From: [Ritzen, Brenda](#)
To: [Lauren Dowlearn](#)
Subject: Permit 117593
Date: Thursday, June 27, 2024 3:37:00 PM
Attachments: [image001.png](#)

**Re: William & Kathryn Alger
Canyon Lake Hills Unit 5 Lot 2199
Application for Permit for Authorization to Construct an On-Site
Sewage Facility (OSSF)**

KATHRYN & WILLIAM ALGER
 730 STAGECOACH DR
 CANYON LAKE, TX 78133
 CANYON LAKE HILLS
 UNIT 5, LOT 2199
 COMAL COUNTY / 0.2745 ACRES

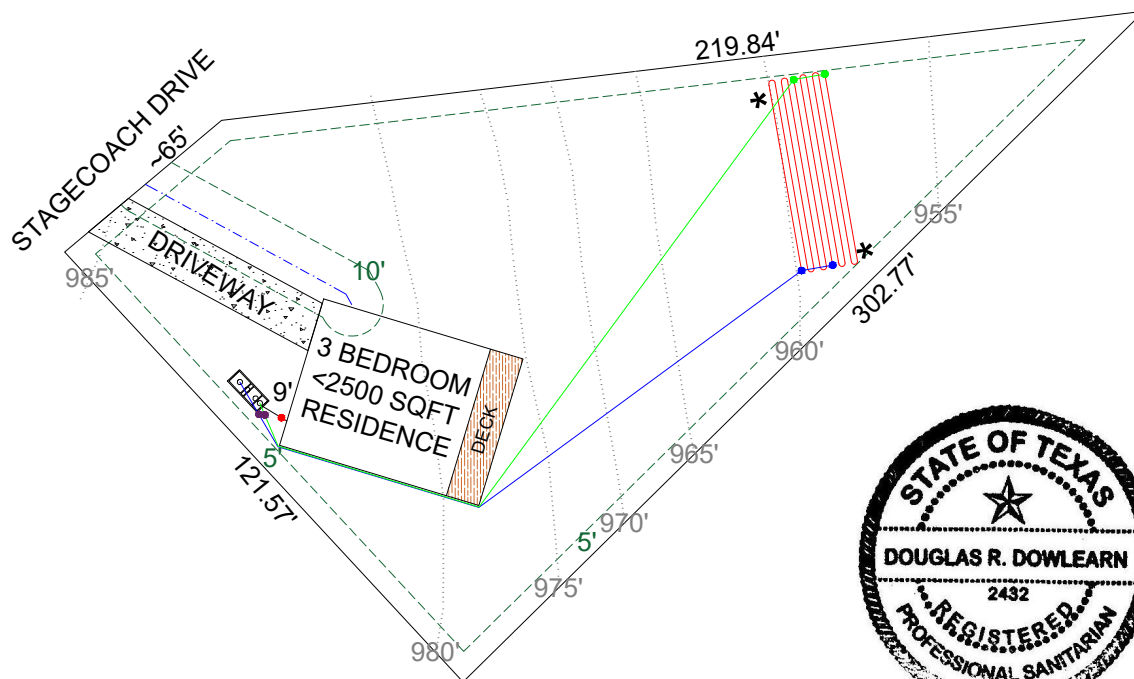
- 1. Identify setback to easements on the design.**
- 2. The property owner must sign the 2 year initial maintenance contract.**
- 3. Is there any Corps of Engineers flowage easement located on the property?**
- 4. A preliminary inspection is scheduled for tomorrow. Additional comments may be necessary once complete.**
- 5. Revise as needed and resubmit.**
